RE: **PETITION NO. 1678** - The Connecticut Light and Power Company d/b/a Eversource Energy petition for a declaratory ruling, pursuant to Connecticut General Statutes §4-176 and §16-50k, for the proposed West Devvon Junction to Devon Substation Rebuild Project consisting of the replacement and reconductoring of electric transmission line structures along approximately 2.17 miles of its existing 115-kilovolt (kV) 1483, 1545, 1580 and 1590 Lines right-of-way and approximately 0.17 miles of its existing 115-kV 1710 and 1730 Lines located on Eversource-owned property on each side of the Housatonic River Crossing between West Devon Junction in Stratford and Devon Substation in Milford, Connecticut, and related electric transmission line and substation improvements.

Eversource respectfully submits replies to interrogatories CSC-01 through CSC-45 for Petition No. 1678. This letter submittal provides an original and 15 copies of the responses.

EVERSOURCE									
West Devon Junction to Devon Substation Rebuild Project Existing Conditions									
Stratford & Milford, CT					Map Sheet 1A of 2				
Date: November 06, 2025					Tighe&Bond				
NO.	DATE	REVISIONS	BY	CHK	APP	APP			
1	2025.11.06	Existing Conditions	TB

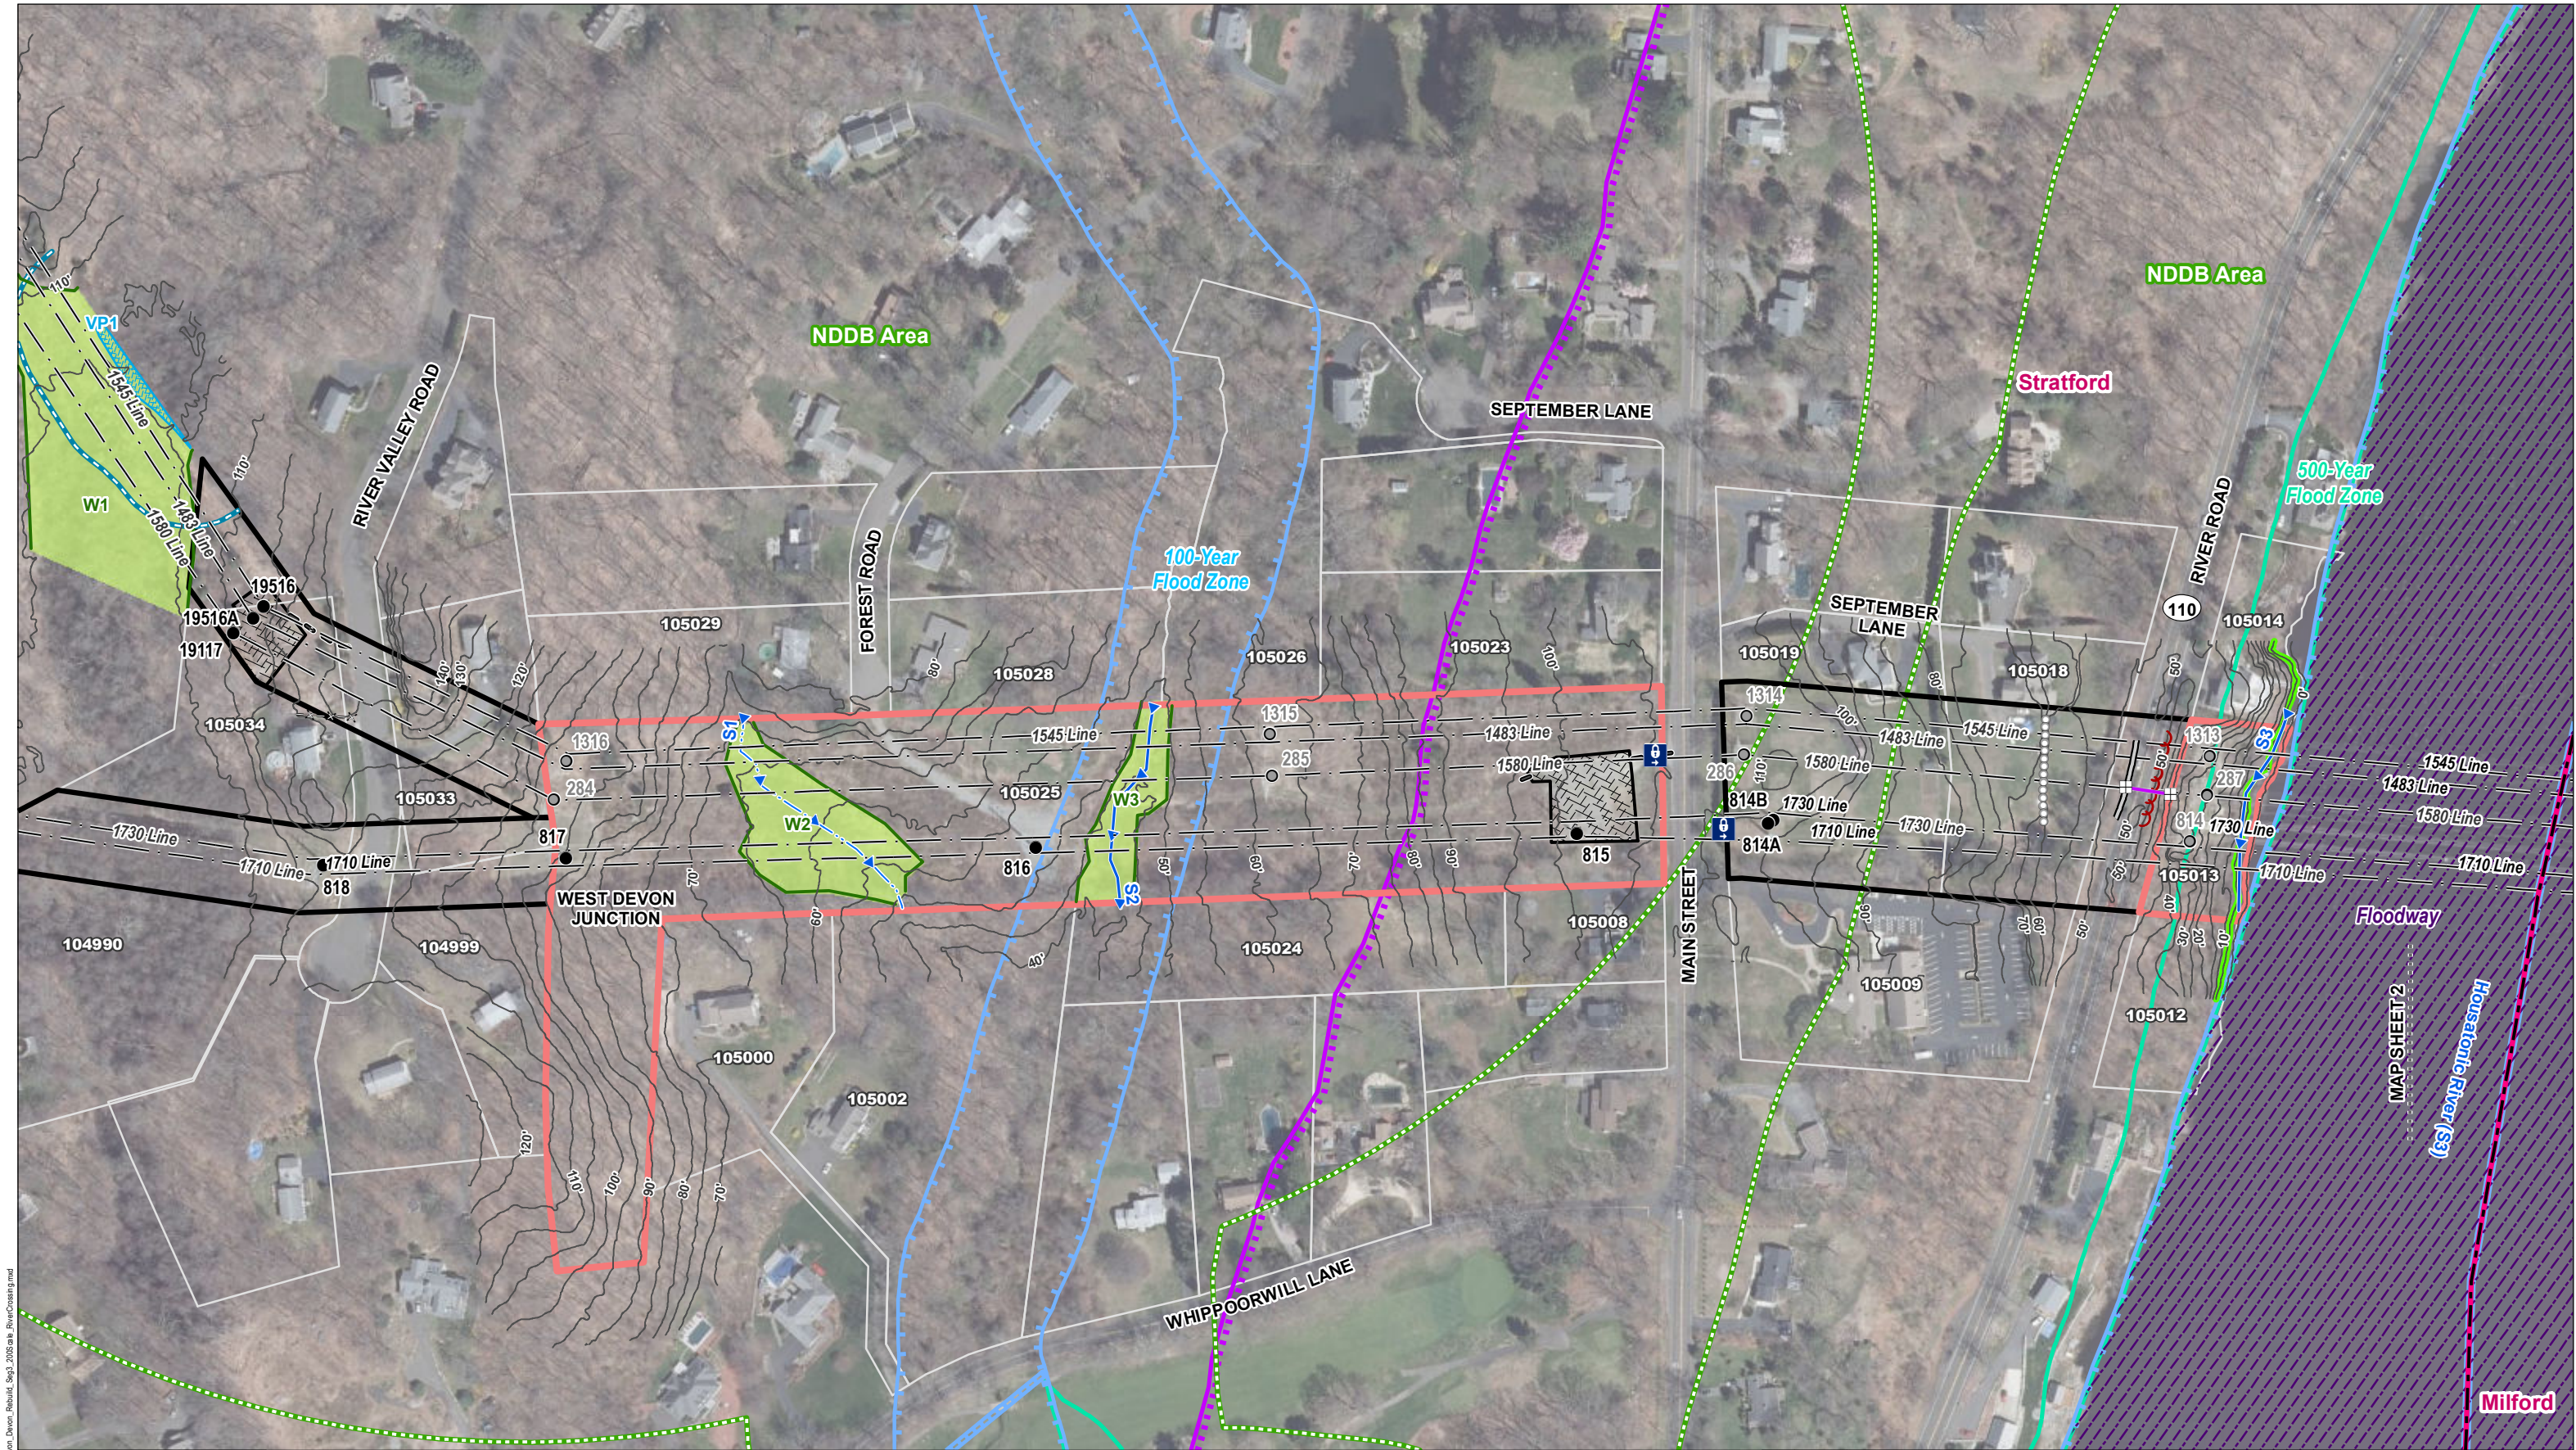
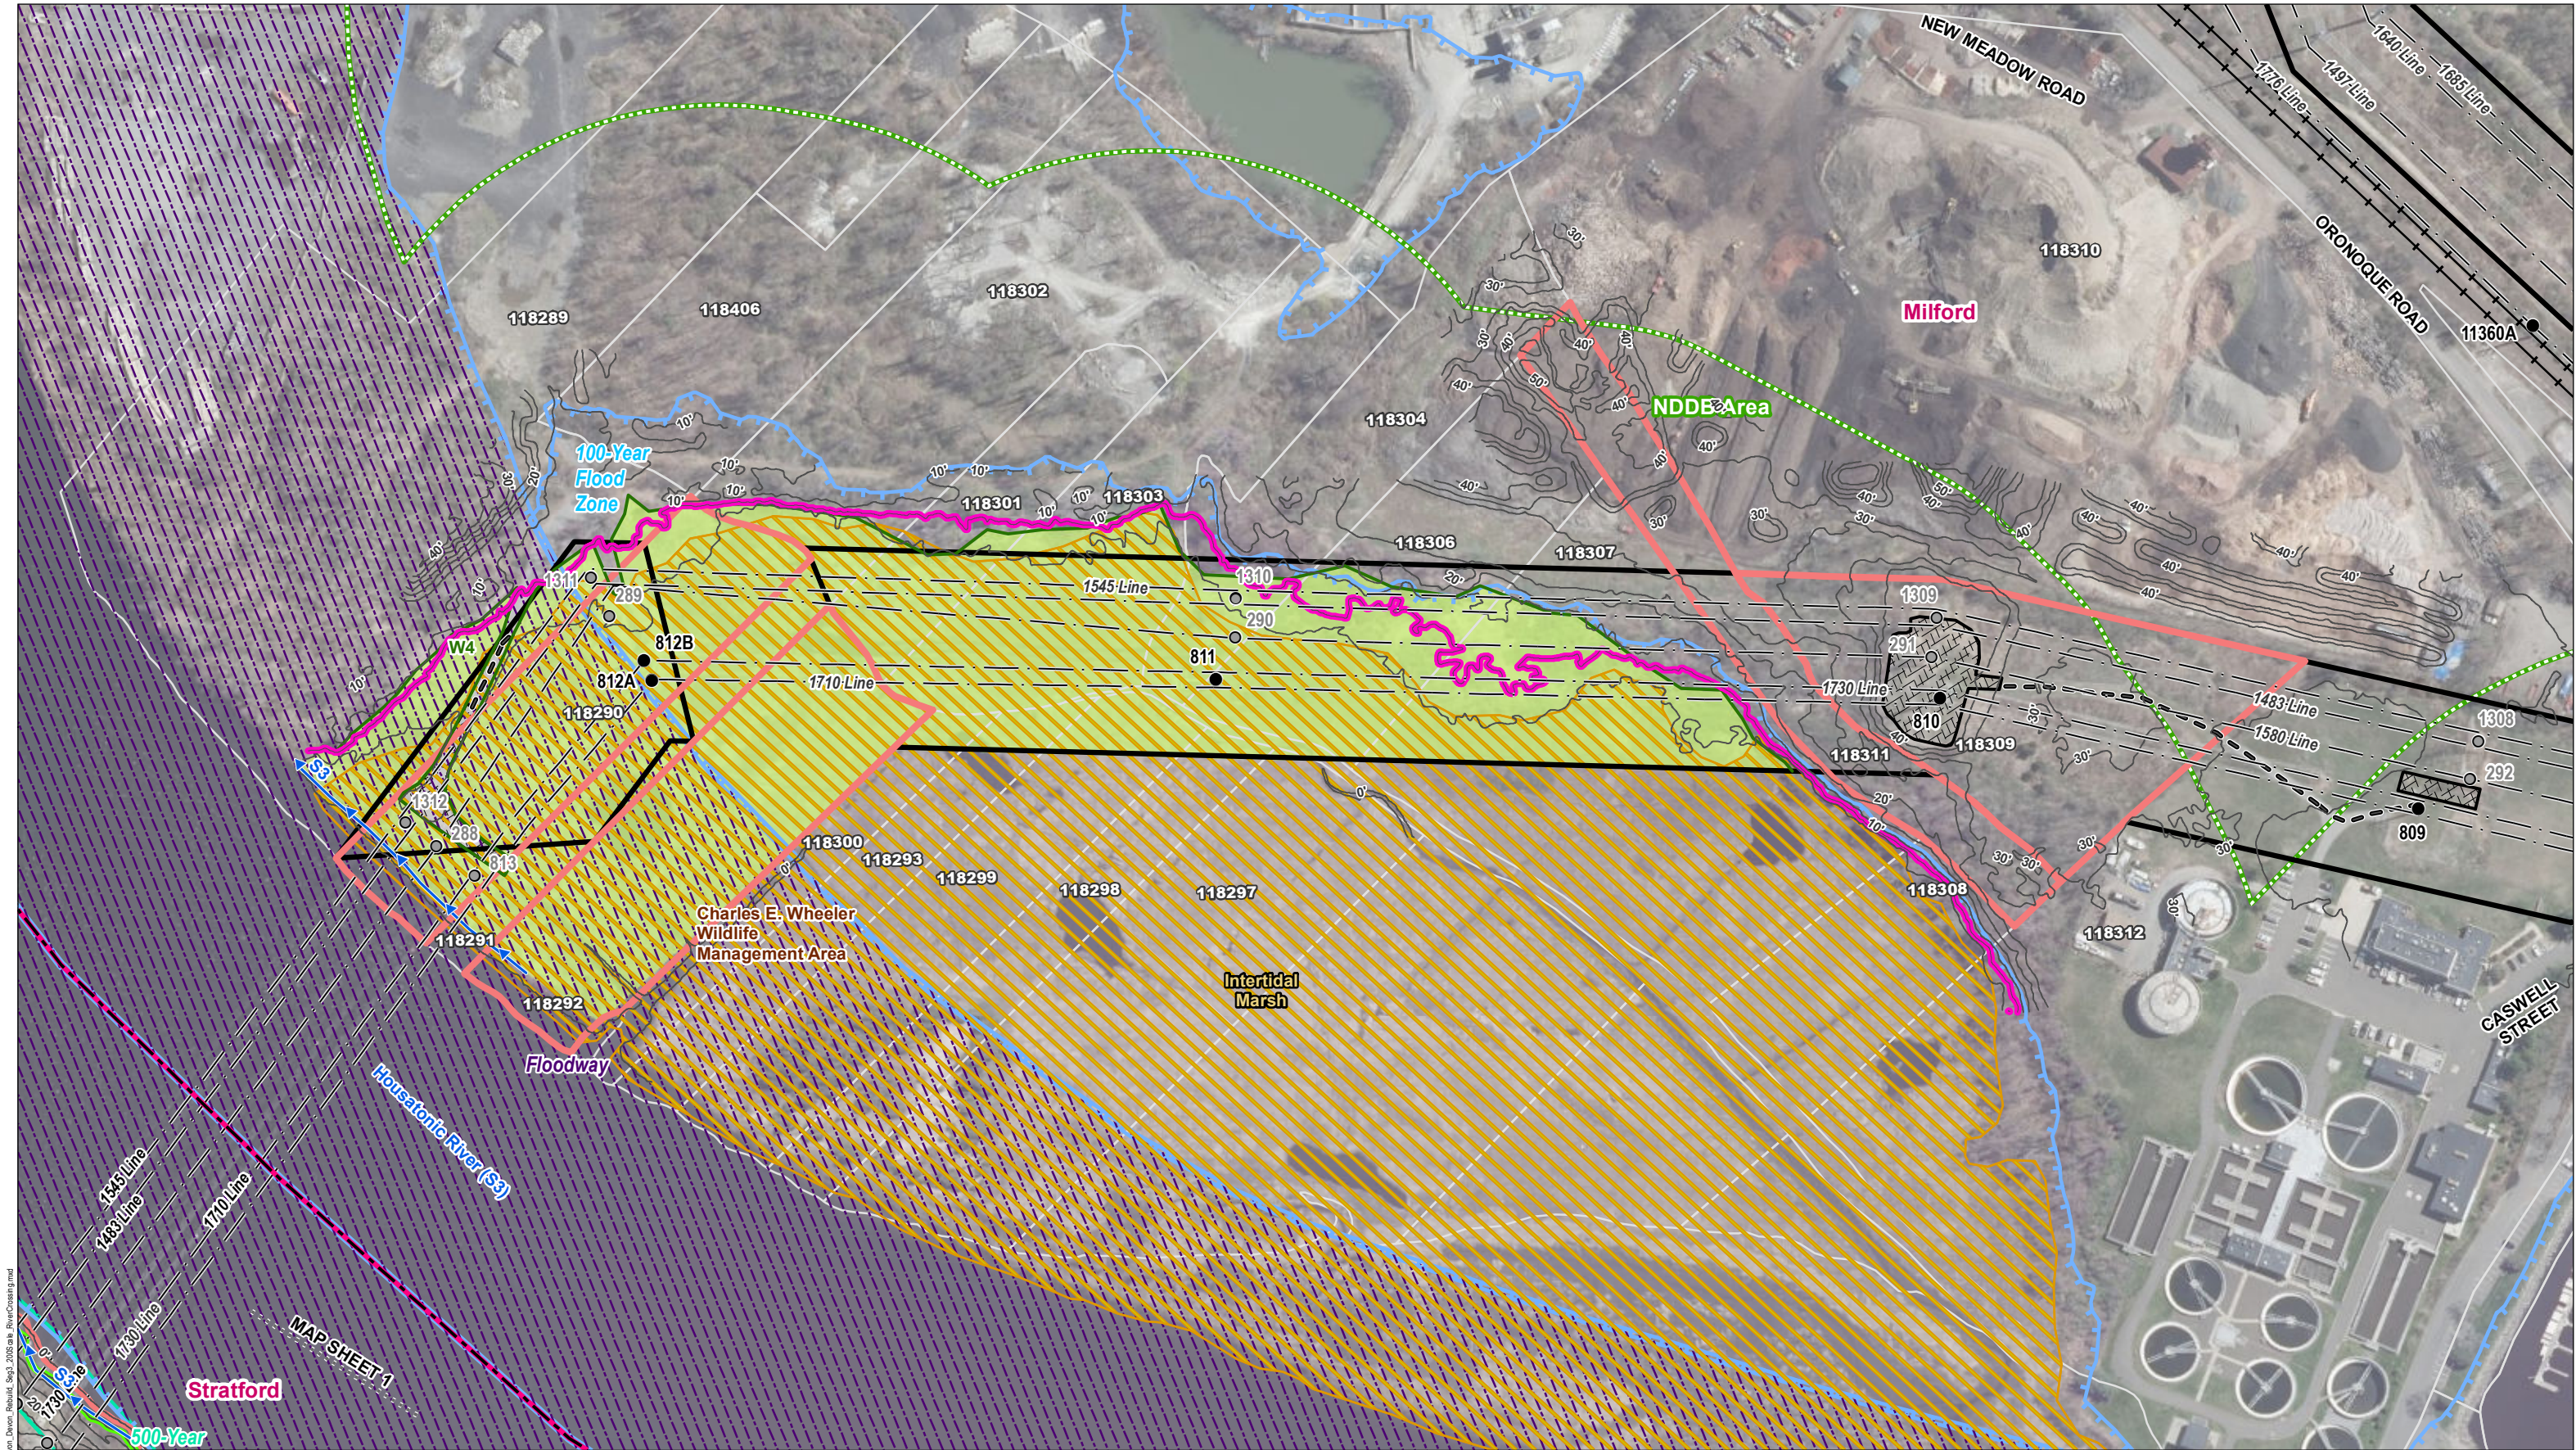
Question: Referencing Map Sheets 1 and 2, provide an aerial image of the river crossing area that only shows existing conditions and structures.

An aerial image of the Housatonic River crossing area that only shows existing conditions and structures is shown in CSC-001\_Attachment Q4, Map Sheets 1A and 2A.

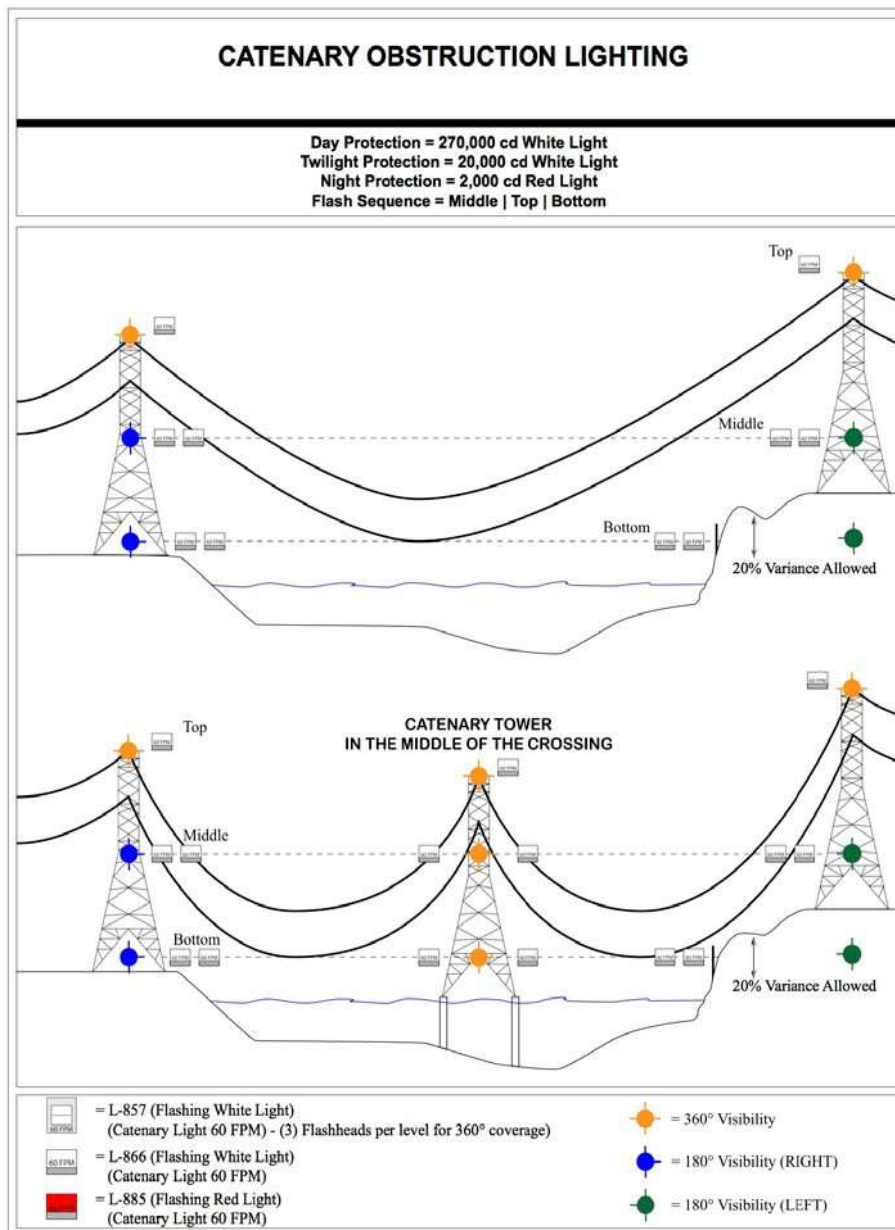
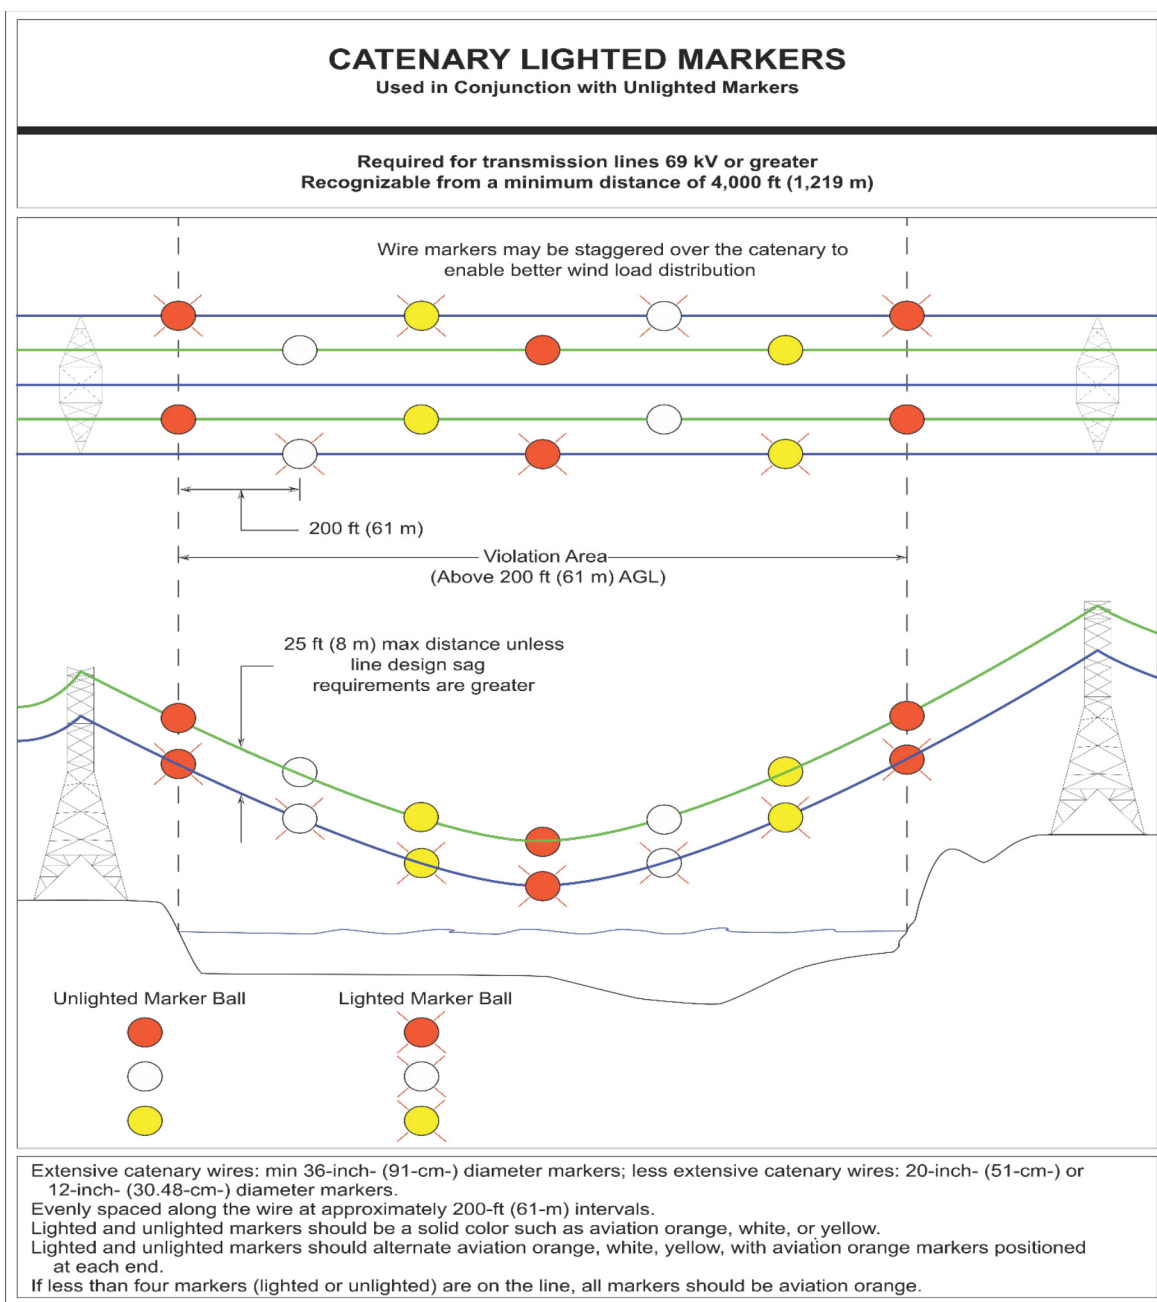
Question: Referencing Petition p. 26, provide the proposed marking/lighting plans for Structures 813 and 814 and marker ball plans if available and describe how the plans comply with any FAA marking/lighting standards.

Project specific marking/lighting plans for proposed Structures 813 and 814 and marker ball plan (1710/1730 lines) have not yet been developed; however, the plans will be consistent with FAA Advisory Circular 70/7460-1 M, as shown in the attached figures:

- CSC-001\_Attachment Q28A: Catenary Obstruction Lighting
- CSC-001\_Attachment Q28B: Catenary Lighted Markers
